**Report for the ACCC**

## Assessment of possible modifications to the Analysys cost model

Based on investigation of operator submissions

*29 September 2010*

Figure 4.1: Deployment of jointing in a pillar implied by the Lordan CAN report [Source: Lordan CAN report]

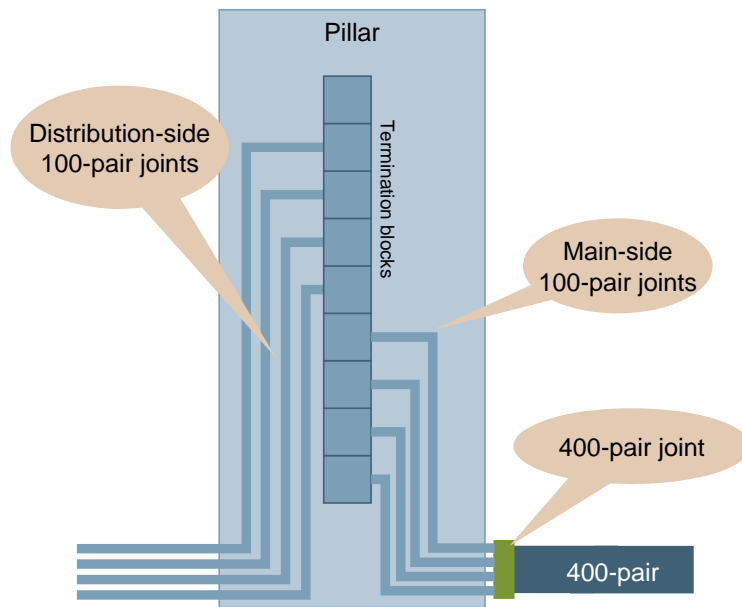
Telstra’s explanation of the issue is not entirely consistent with that in the Lordan CAN report<sup>4</sup>. In paragraph 7.30, this states:

This implies a deployment as shown below in Figure 4.1.

Therefore, Telstra's proposed modification to add in a 400-pair joint for each pillar/LPGS is not quite sufficient. In reality, Lordan highlights that the 400-pair joint effectively splits the 400-pair cable out into four 100-pair cables, which are then each jointed with a 100-pair joint onto the frame inside the pillar/LPGS. This is necessary because a 400-pair cable is too thick to move around within the pillar/LPGS housing. Correspondingly, we can reduce the capex of the pillar/LPGS by the cost of one 400-pair joint and four 100-pair joints on the main cable side. This change has a negligible impact on the model.

Figure 4.5: Inclusion of extra thicker gauge main cable [Source: Analysys Mason]

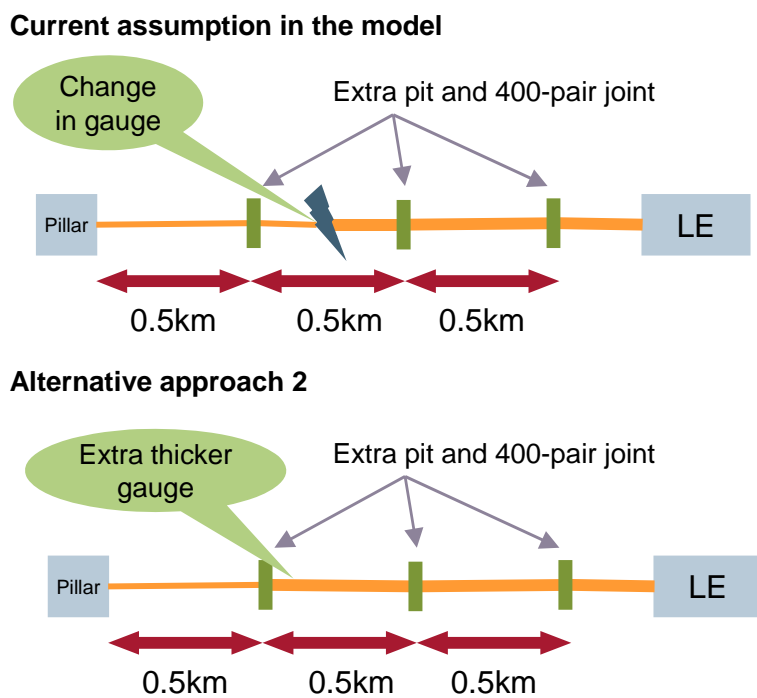
Main cables are jointed at least every 500m in the model. If a gauge change is required between two such joints, then the higher gauge can be (conservatively) assumed to extend to the joint furthest downstream, as shown in Figure 4.5 below.

We have revised the formulae in a version of *Cable gauge determination.xls* to use this more conservative assumption, allowing a revised gauge distribution to be calculated and used in the Cost module.

Figure 4.6: Inclusion of an extra pit and joint  
[Source: Analysys Mason]

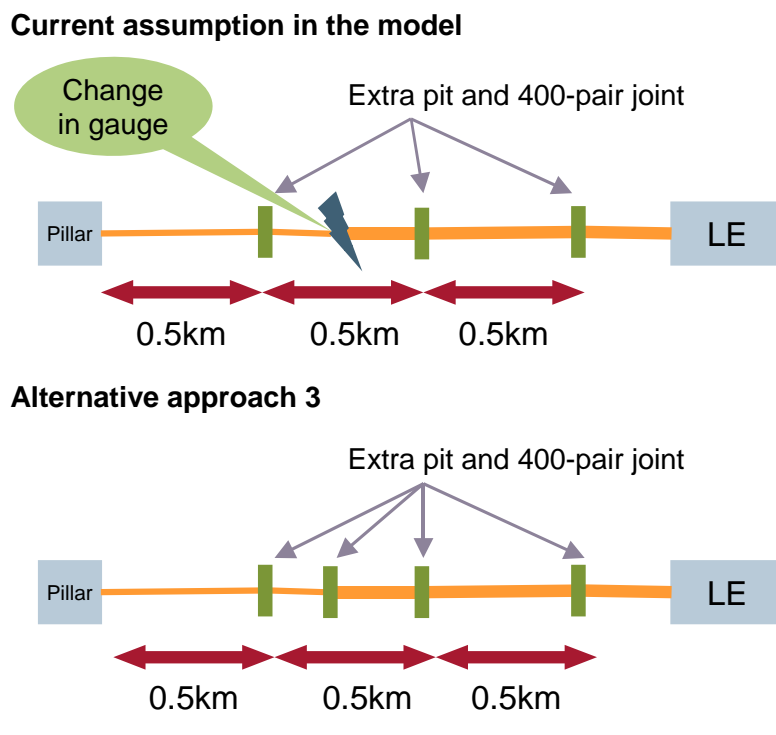
Using the information from *Cable gauge determination.xls* as to what proportion of pillars require two main cable gauges, we can deploy an extra joint and pit at this proportion of pillars, as shown in Figure 4.6 below.

Using Approach 3, an extra pit for each change in main cable gauge adds less cost into the access network than adding in more thicker gauge cable. We note that the cost of the former is AUD1320 for a P5 and a 400-pair joint, whereas the cost of thicker gauge cable is AUD35 per metre for

Figure 4.7: Lead-in assets that should be included/excluded [Source: Analysys Mason]

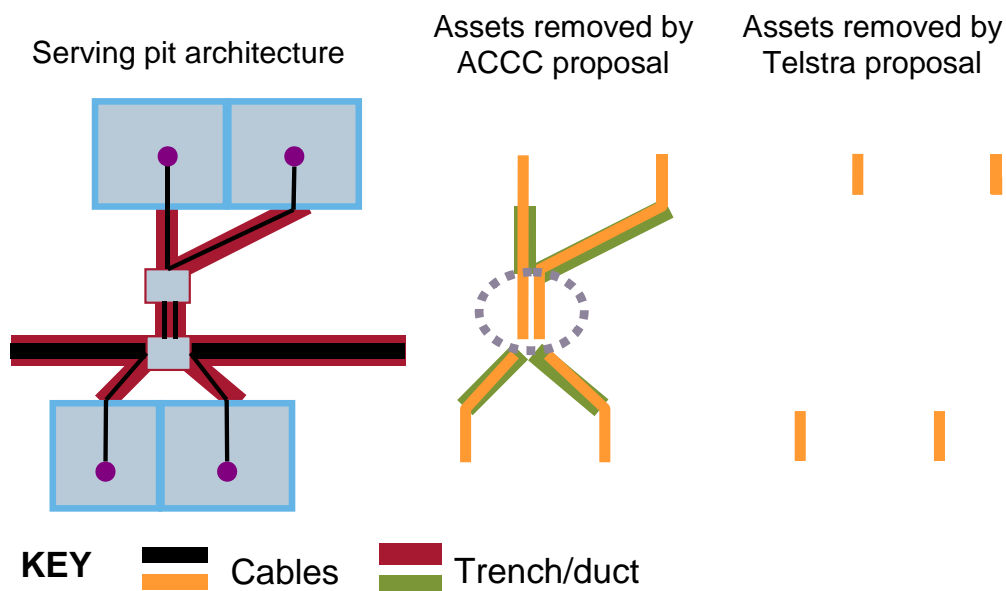
We understand this issue is a result of the ACCC decision to exclude these costs from its own version of the model used in the draft pricing principles paper. The assets that should be excluded according to the ACCC and Telstra are shown below in Figure 4.7.

In particular, we understood that the ACCC wanted to remove the cable and trench assets from the serving pits to the NTP. This was implemented by the ACCC by setting the costs of the “Duct: 1 (PB >> DP/ Serving pit)” and “Copper lead-in: 2” assets to zero. We note that this did not remove the lead-in cables larger than 2-pair, but removed the 2-pair cables in the road crossings. Based on our understanding of connection charges, cables within road crossings to the “across road” serving pits remain with Telstra. Therefore, we propose that these cable assets be kept in the Cost module. It is more consistent to exclude the necessary assets in the CAN module, rather than de-activate the costs. Therefore, we have added switches to the Cost module to remove the lead-in assets if desired (i.e. all cables from the serving pit to NTP), so that the unit costs do not need to be set to zero. Assets from the NTP to the property boundary (PB) and from the PB to the serving pits can be switched on/off separately.

Figure 4.8: Comparison of level of CAN/IEN-sharing nationally and by geotype [Source: Analysys Mason]

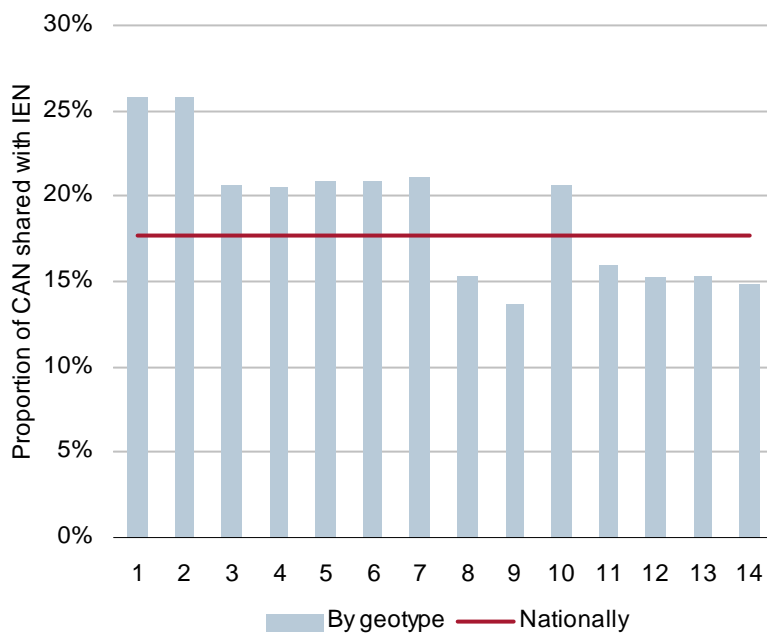
Telstra’s approach is to split the IEN 2-duct requirements evenly by geotype and CAN trench size based on the level of CAN/IEN sharing (18%). We have considered both this and a similar approach, which allocates IEN 2-duct across the trench sizes in the CAN based on the level of CAN/IEN sharing by geotype. These two approaches are summarised below in Figure 4.8.

As can be seen above, Telstra’s approach of a national level of sharing hides the imbalance of the level of sharing between Zones A and B. Therefore, we believe it is appropriate to derive IEN/CAN-sharing by geotype.

Figure 4.9: Distribution of CAN trench (a) before any adjustment, (b) using Telstra's suggested adjustment using national IEN/CAN sharing and (c) our approach using IEN/CAN sharing by geotype [Source: Analysys Mason]

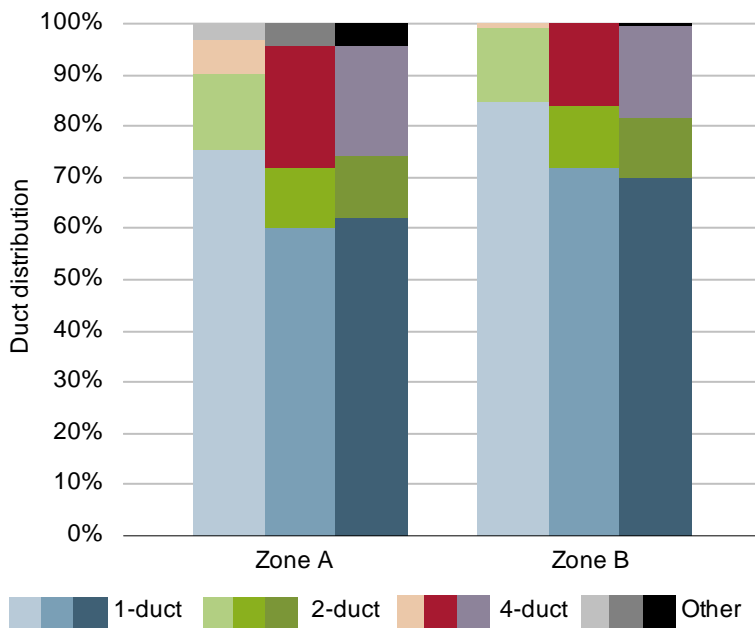
The five largest ducts increase in size in steps of four ducts. Only 9% of these are upgraded since, statistically, 50% of them will contain two or more empty ducts. None of the four smallest duct sizes can have two empty ducts. Our approach follows the same upgrade principle, except that we use our IEN/CAN-sharing percentages calculated by geotype. The new duct distributions of the combined IEN/CAN network are compared with the original distribution below for both zones in Figure 4.9.

Both approaches drastically increase the amount of 4-duct trench deployed in the network. This is because a significant proportion of 1-duct and 2-duct trench requires two more ducts, meaning that 4-duct is deployed. Although our approach deploys slightly longer routes with more duct in Zone A, it deploys shorter routes with more duct in Zone B.

Figure 4.10: Distribution of CAN pits (a) before any adjustment, (b) using Telstra's suggested adjustment using national IEN/CAN sharing and (c) our approach using IEN/CAN sharing by geotype [Source: Analysys Mason]

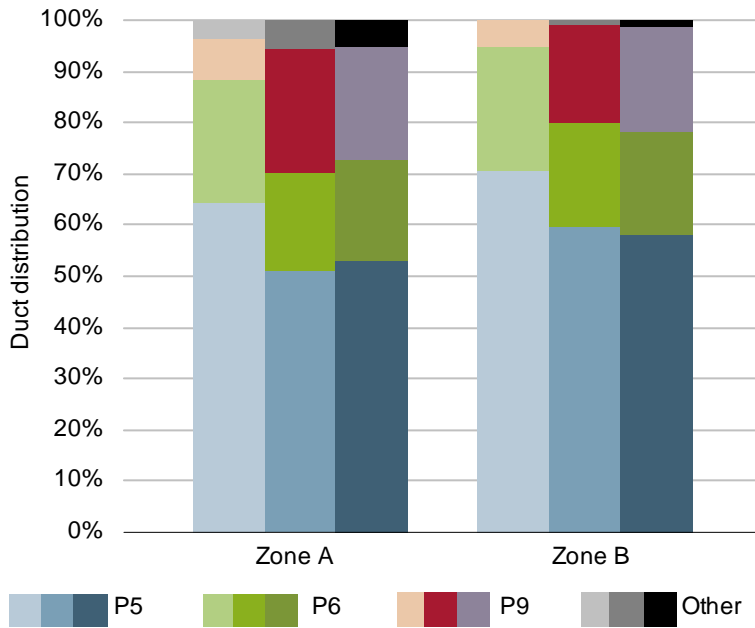
Telstra's approach to adjusting the pit distribution is also based on the proportion of IEN trench sharing with the CAN. We have implemented an analogous approach using our sharing percentages by geotype. These change the pit distribution as shown below in Figure 4.9.

The effect is to drastically increase the number of larger pits deployed in the network, effectively since P9 pits must be deployed in place of any P5/P6 pits deployed where the IEN duct shares the CAN trench.

Figure 4.11: Cost allocation options for the main network as access network assets [Source: Analysys Mason]

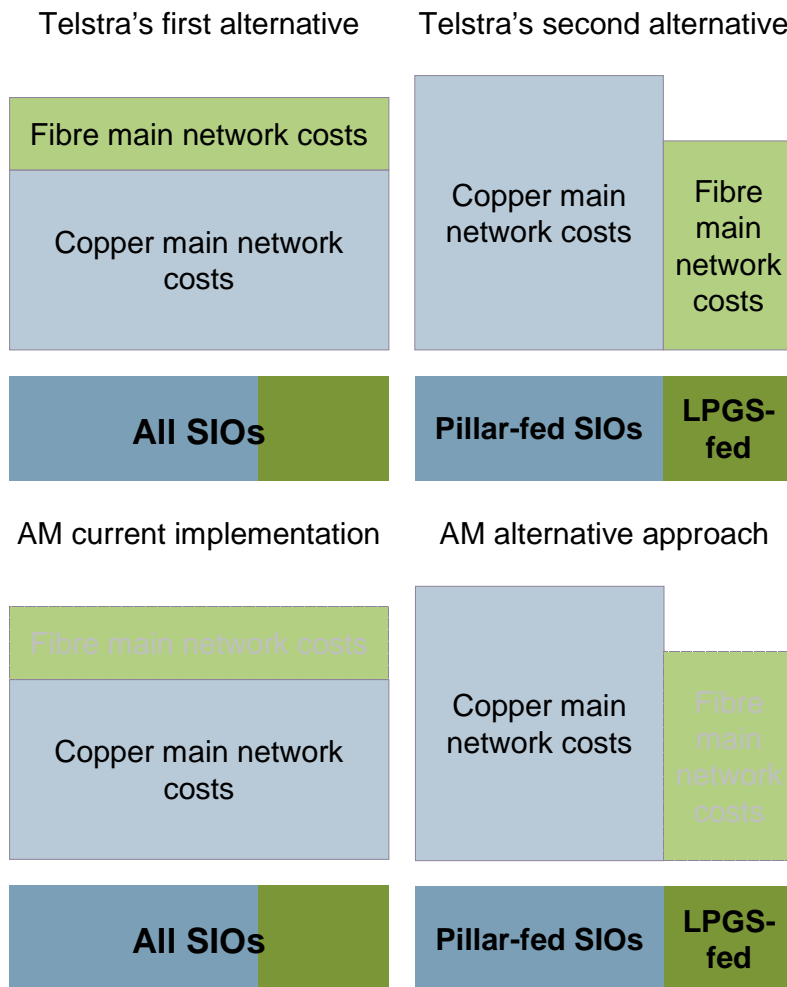
The Analysys Model does not properly determine the unit cost of CAN services because it contains a mismatch between the annual cost and the services in operation used in the calculation. The model builds a network comprised of copper, fibre, wireless, and satellite components, then removes the investment in those components (fibre, wireless, and satellite in the case of ULLS), but does not remove from the unit cost calculation those SIOs served by the excluded network components.

Our current implementation is similar to the first option, except that fibre main cable costs are allocated to the core network and not as access costs: this is illustrated below in Figure 4.11.

We recommend implementing this change. However, should the ACCC not wish to implement this change, then it can be easily de-activated in the model, since it is driven by two sets of input cells (A8:A37 and A46:A146) on the *Dem.In.Access* worksheet in the Cost module. By setting the latter cells to zero, the routeing factors will be applied exactly as before.

Figure 4.13: Comparison of dial-up forecasts  
[Source: Analysys Mason, Telstra]

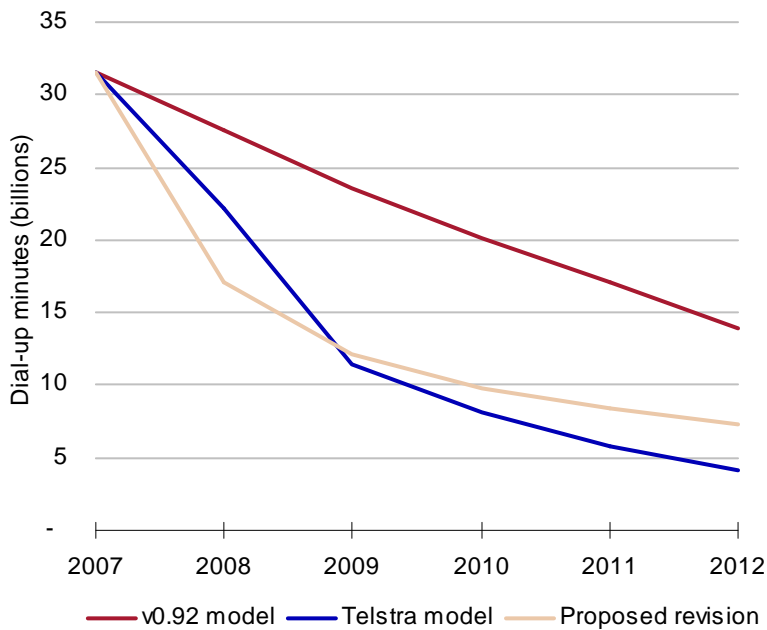
Telstra indicates in its submission that there is a steep decline in traffic between 2007 and 2009, which can be reflected by an early exponential curve using a 24% CAGR. A comparison of the original model, the Telstra forecast and our proposed revised forecast is given below in Figure 4.13.

Our revised forecast uses existing functionality in the model and better reflects the trend in traffic indicated by Telstra, although it under-estimates dial-up traffic in 2008.

Figure 5.7: Increase in average cabling metres (property boundary to DP) for the Zone A geotypes [Source: Analysys Mason]

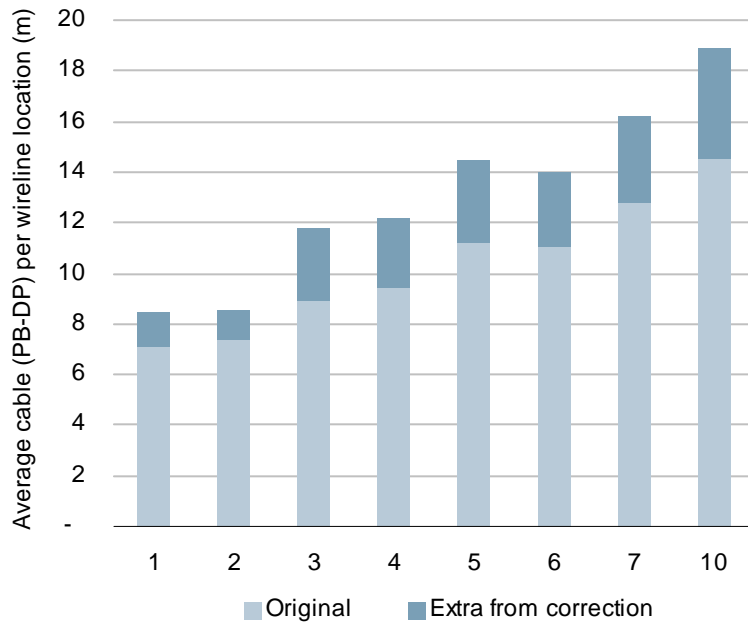
Telstra has identified that the calculation for final-drop cable in road-crossings is incorrect. Effectively, only one cable is provisioned in the road-crossing, whereas in some cases 2, 3 or even 4 cables will sometimes be required. We have corrected this error in the CAN module, in row 218 of the *Access* worksheet. We have determined the probabilities of each occurrence (in terms of number of cable road-crossings by size of DP cluster) in an additional table on the *In.Demand* worksheet. This table is shown below in Figure 5.6: we use the weighted-average number of road-crossing cables by DP cluster size to derive the cabling required.

This has the effect of increasing the lead-in cable sheath by approximately 6% across the urban geotypes (Zone A), as shown below in Figure 5.7. It is important to note that this correction has no effect on the deployment in the rural geotypes (Zone B) since these ESAs do not use the serving pit architecture: every connected location has its own pit.

Figure 6.2: Part of the diagram in the TEA model documentation  
[Source: Telstra]

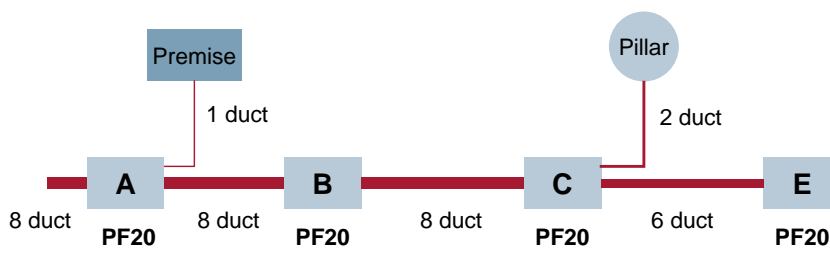
Firstly, we note that in Telstra's own public TEA network design rules document,<sup>13</sup> the diagram on page 13 shows that Telstra's pits are dimensioned on the maximum number of ducts leaving one end, rather than the total number of ducts entering the pit. Figure 6.2 below illustrates part of this diagram.

According to the adjacent table on page 13 of the Telstra document, a PF20 has a capacity of up to 12 ducts. This means 12 ducts at each end, otherwise larger pits would be required at A, B and C.

Figure 6.6: Duct deployed around the Bundanoon (BUND) exchange [Source: Analysys Mason]

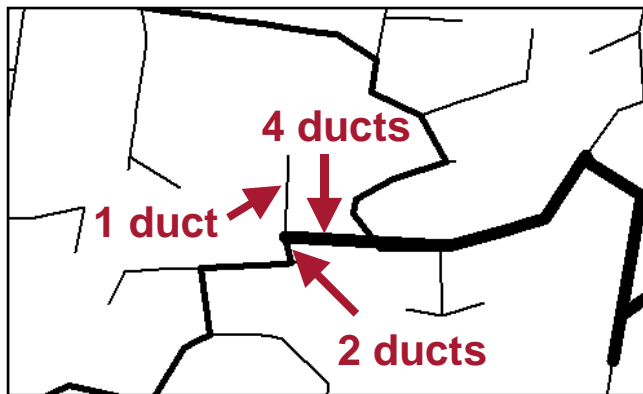
This error is clearly demonstrated by Telstra's example in ESA 8.4, although the operator did not identify it. For the calculation of the LE location, the maximum number of ducts entering the LE is stated to be 3. However, the printed duct requirements for the trench network links show that this link has 3 ducts required, but 4 deployed (3 cannot be deployed according to our engineering rules).

We have corrected the Visual Basic to consider the deployed ducts in the calculation.

Figure 6.7: Change in pit size distribution by geotype [Source: Analysys Mason]

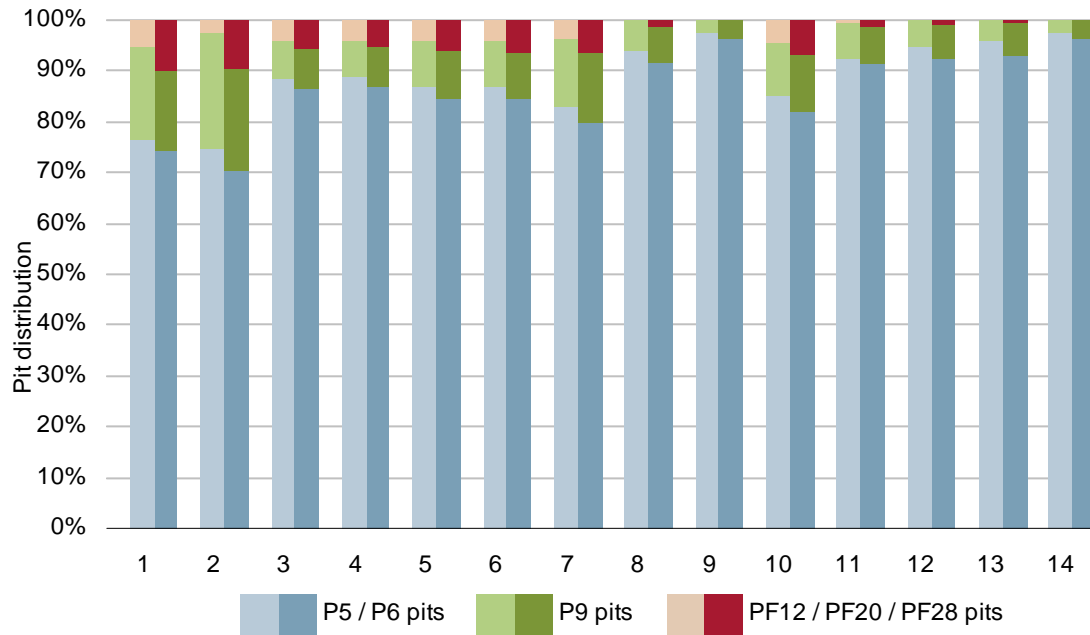
We have re-run the geanalysis following these changes. There is a move in the pit size distribution towards the larger pits in each geotype, as shown below in Figure 6.7.

The ACCC should incorporate the revised changes into the geoanalysis.
